Safety Recall

N242441391 Left Side Seatbelt Retractor May Lock

Release Date: September 2024

Revision: 03

6682024

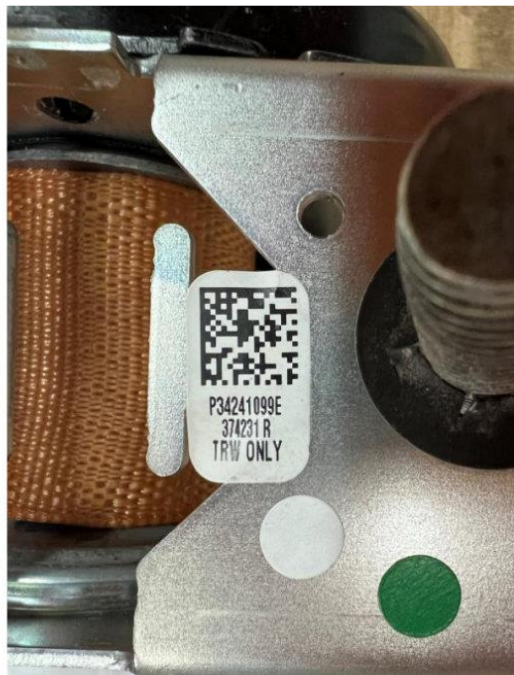
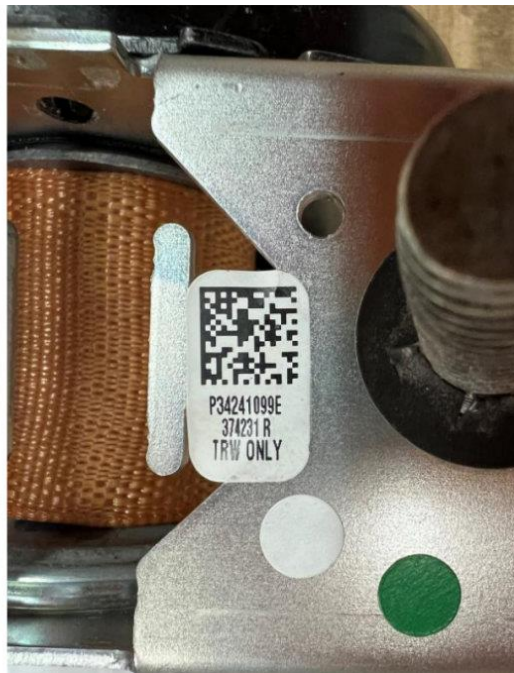
Important: DO NOT install the replacement Seatbelt Retractor if they fail one or both inspections below.

1. Inspect the NEW Seatbelt Retractor label located on the bottom of the Seatbelt Retractor.
 - If the 4th and 5th digits are “23” AND the 1st and 2nd digits range between “35”-“52”, The part is BAD and MUST be scrapped. DO NOT INSTALL ON VEHICLE. Reference the Scrap Instructions below. Re-order a replacement Seatbelt Retractor and repeat inspection.
 - If the 4th and 5th digits are “23” AND the 1st and 2nd digits DO NOT range between “35”-“52” proceed to Step 3.
 - If the 4th and 5th digits are “24”, Proceed to Step 2.

2. Continue to inspect the NEW Seatbelt Retractor label located on the bottom of them retractor.
 - If the 4th and 5th digits are "24" AND the 1st and 2nd digits are "01", The part is BAD. DO NOT INSTALL ON VEHICLE. Re-order a replacement Seatbelt Retractor and repeat inspection.
 - If the 4th and 5th digits are "24" AND the 1st and 2nd digits are NOT "01" proceed to Step 3.
3. Replace the LH Front Seat Belt Retractor. Refer to *Front Seat Belt Retractor Replacement* in SI. If convertible, refer to *Front Seat Belt Retractor Replacement - Left Side (Convertible)* in SI.
4. Scrap all replacement Seat Belt Retractors that failed inspection steps 1 and/or 2 AND the used Seatbelt Retractor. Refer to the Scrap instructions below.
